**MONTGOMERY COUNTY HISTORIC PRESERVATION COMMISSION**  
**STAFF REPORT**

<b>Address:</b>	10212 Montgomery Ave., Kensington	<b>Meeting Date:</b>	1/10/2024
<b>Resource:</b>	Primary One Resource <b>Kensington Historic District</b>	<b>Report Date:</b>	1/3/2024
<b>Applicant:</b>	Warner Circle Mansion Condominiums, LLC (Karl Voglmayr, Agent)	<b>Public Notice:</b>	12/27/2023
<b>Review:</b>	HAWP	<b>Tax Credit:</b>	Partial
<b>Permit No.:</b>	1032588 REVISION	<b>Staff:</b>	Dan Bruechert
<b>Proposal:</b>	Post-approval revisions for comprehensive rehabilitation, new addition, site alterations and grading

## WARNER MANSION RENOVATION & ADDITION – HPC REVIEW

*Figure 4: East elevation showing the proposed 2nd-floor window revisions.*

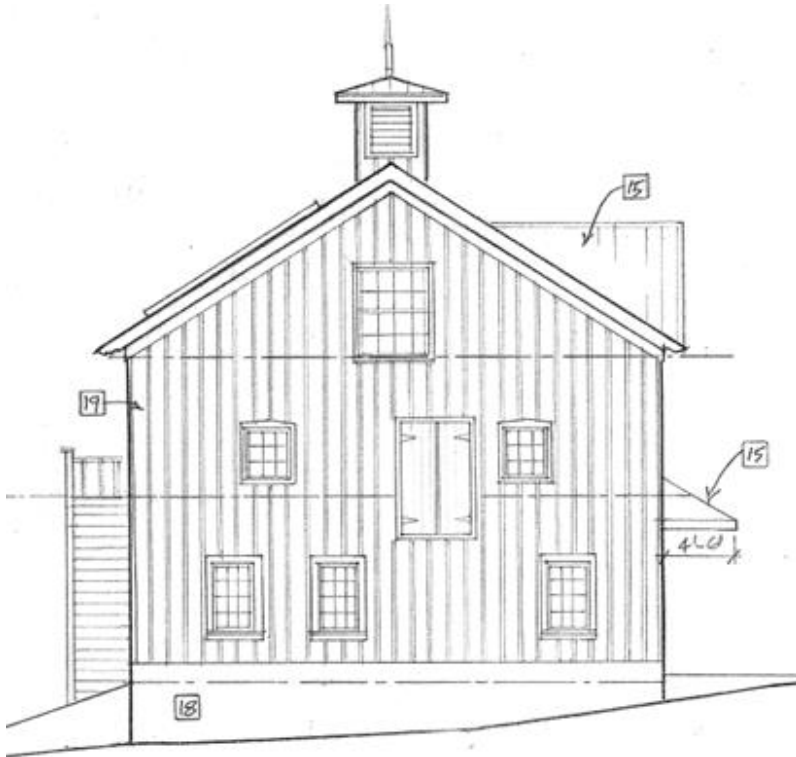
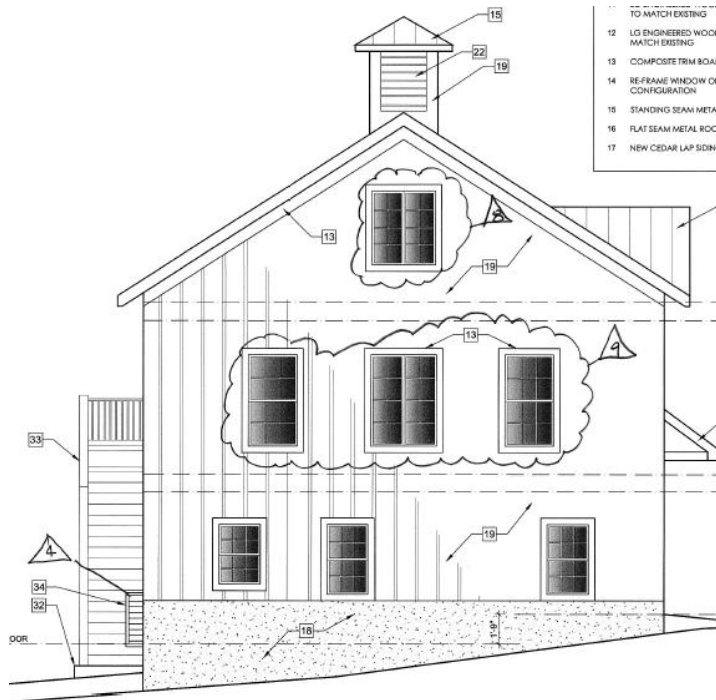
9. 3 windows Altered – On the 2<sup>nd</sup> floor of the east elevation there are three openings, two small louvered openings, and a large opening, slightly off-center, with a hoist to load the hay loft. The applicant proposes to significantly enlarge the two louvered openings and center the hay loft opening, remove the doors, and install a pair of 8-light casement windows (images of the existing condition, approved, and the proposed revision are shown below). The approved plan converted the two louvered openings to casement windows and retained the loft opening. Staff finds the collective impact of these three changes is detrimental to the character of the elevation and recommends the HPC consider an alternative. Staff recommends the HPC not approve enlarging the left and right openings. The floorplan submitted with the approved HAWP shows the hay loft door in the location of a closet, so retaining the doors would not have interfered with the interior layout. Staff recommends the HPC allow the hay loft opening to be glazed, provided the hoist is retained and the doors are retained (or replaced as necessary). The hay loft doors may be installed in a fixed open position, but are necessary to preserve the character of the carriage house so it can convey how it historically functioned. With the condition, Staff finds the proposal is consistent with 24A-8(b)(2) and Standard 2.

1. The proposed revisions to the 2<sup>nd</sup> floor of the east elevation of the carriage house are incompatible with the character of the building. No additional changes are approved to the left and right windows. The middle opening may be converted to a window but must maintain the hoist and doors. The doors may be fixed in an open position. Final approval authority to verify this condition has been satisfied is delegated to Staff.

Figure 6: Revised design showing the additional windows and is corrected to accurately show the shed dormer.

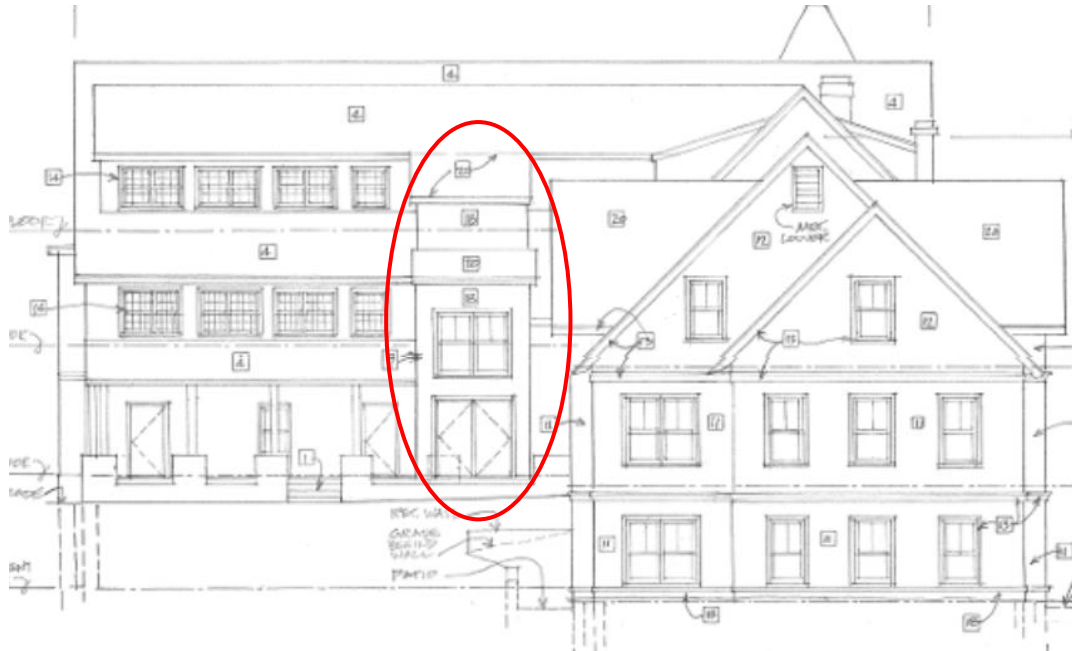
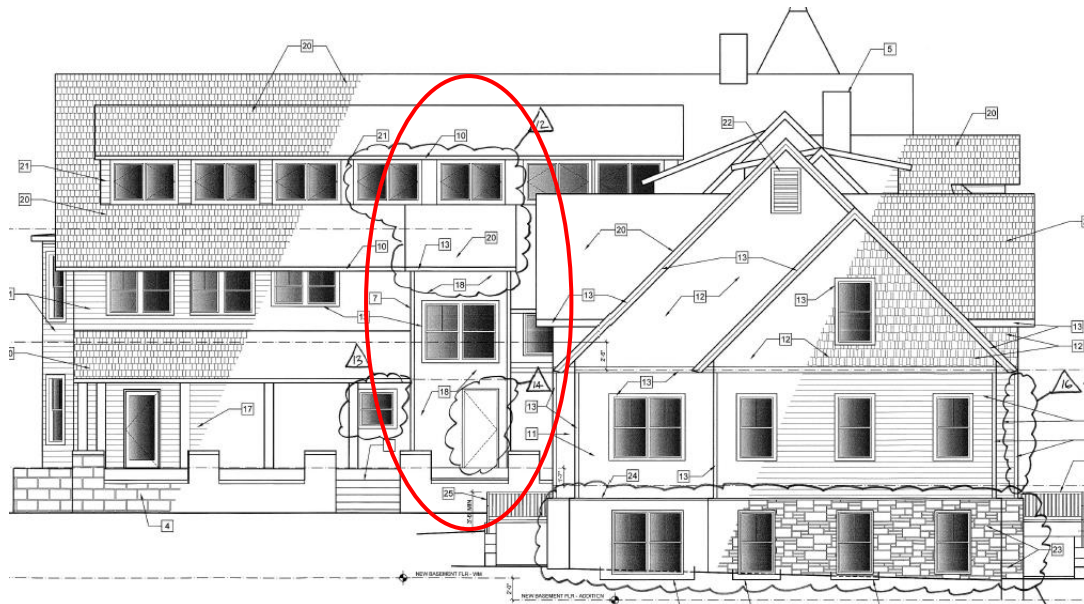
12. Stair Tower Revisions – The approved HAWP drawings show the stair tower roof covering windows in the existing dormer. The applicant proposes to revise the stair design so that 3rd-floor windows are retained. Note, the proposed drawing shows single-light casement windows, however, the drawing is illustrative and only multi-light windows have been approved on this elevation. Staff finds this change will not impact the historic massing of the structure and recommends the HPC approve this revision under 24A-8(b)(2) and Standard 2. The drawing submitted as *Figure 6* corrects a drafting error in the elevation submitted for HAWP approval (*Figure 5*).

*Figure 8: Revised fenestration for the connector.*

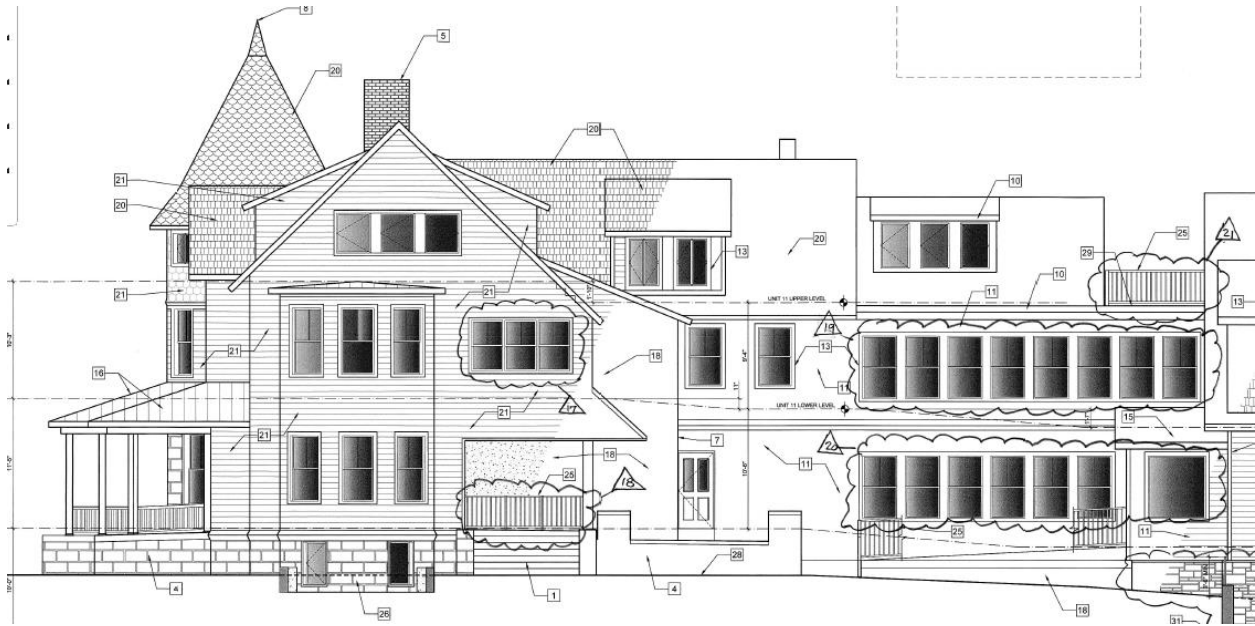
19. Revision of the Connector Fenestration (2<sup>nd</sup> Floor) – the approved design of the 2<sup>nd</sup> floor of the connector between the mansion and the addition included four pairs of sash windows. The revised design has separated the windows into eight individual sash windows. This revision was recommended at the June 16, 2023 hearing and Staff finds creates a more balanced appearance. Staff finds this revision is an improvement on the approved design and recommends the HPC approve the new fenestration under 24A-8(b)(2) and (d) and Standards 2, 9, and 10.

20. Revision to the Connector Fenestration (1<sup>st</sup> Floor) – On the approved design of the 1<sup>st</sup>-floor connector, there was a pair of sash windows in the southernmost opening. The applicant revises the design so that the pair of windows is converted into a single square picture window. Because the 2<sup>nd</sup>-floor windows were unpaired, retaining that opening as a pair of sash windows would have resulted in an incongruous appearance. Staff finds the revised design is consistent with 24A-8(b)(2) and (d) and recommends the HPC approve the revision.

Figure 10: Revised fenestration.

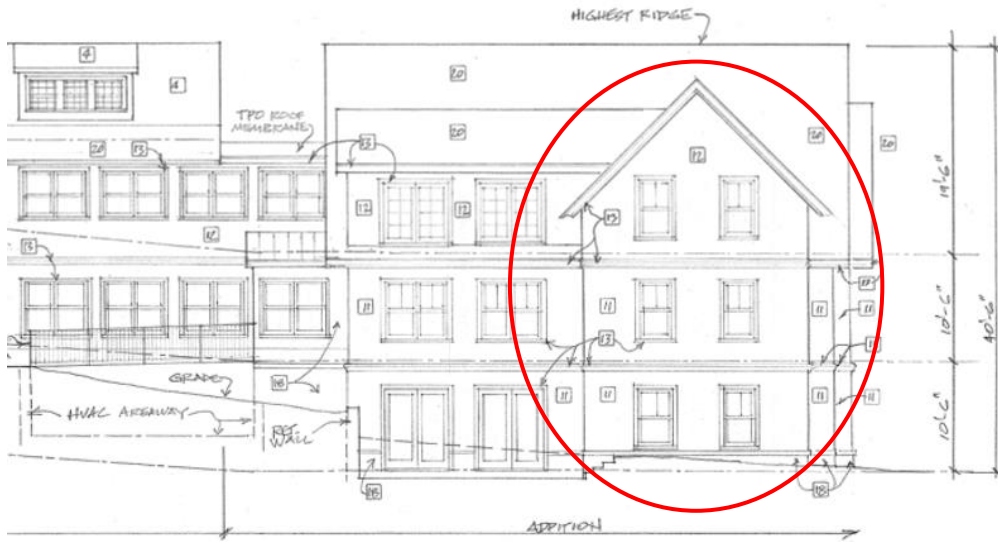
22. 1<sup>st</sup> Floor Addition Changed to Stone Veneer – See #15.
23. Fenestration Revised – On the west elevation of the addition, the approved design had three floors of stacked two-over-one sash windows. The applicant proposes to revise the fenestration so the windows on the basement and 1<sup>st</sup> floor are closer together and there is a single window on the 2<sup>nd</sup> floor. While Staff preferred the previously approved design, Staff finds the revised layout does not detract from the character of the historic site or the surrounding district and recommends the HPC approve the revision under 24A-8(b)(2) and (d) and Standards 2, 9, and 10.

Figure 5: Proposed east elevation.

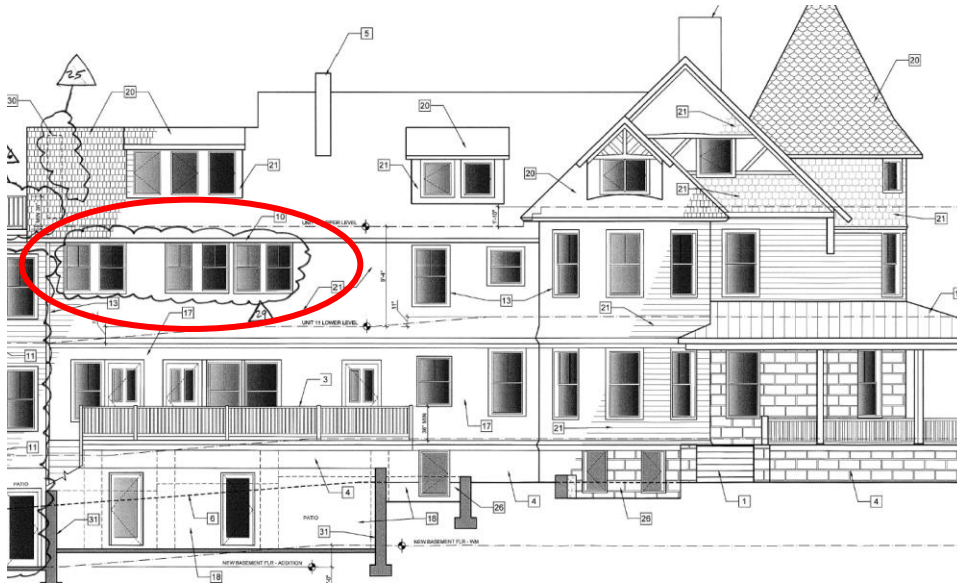
29. Fenestration Revised at 2<sup>nd</sup> Floor – On the 2<sup>nd</sup> floor of the historic house's east elevation, there is a modified window opening that appears to have included three pairs of six-over-six sash windows on one point (two windows are currently missing). The approved design would have restored the opening to include three pairs of windows. The revised design changes the window configuration from six-over-six to two-over-one and changes the window spacing. Staff finds the window configuration change is compatible, but finds the window spacing to be unbalanced. Regardless of the balance, Staff finds this elevation has been substantially altered from its historic configuration including the construction and removal of a non-historic addition projecting to the

east. Staff finds the revised design is appropriate and recommends the HPC approve the new fenestration on the east elevation under 24A-8(b)(2) and (d).
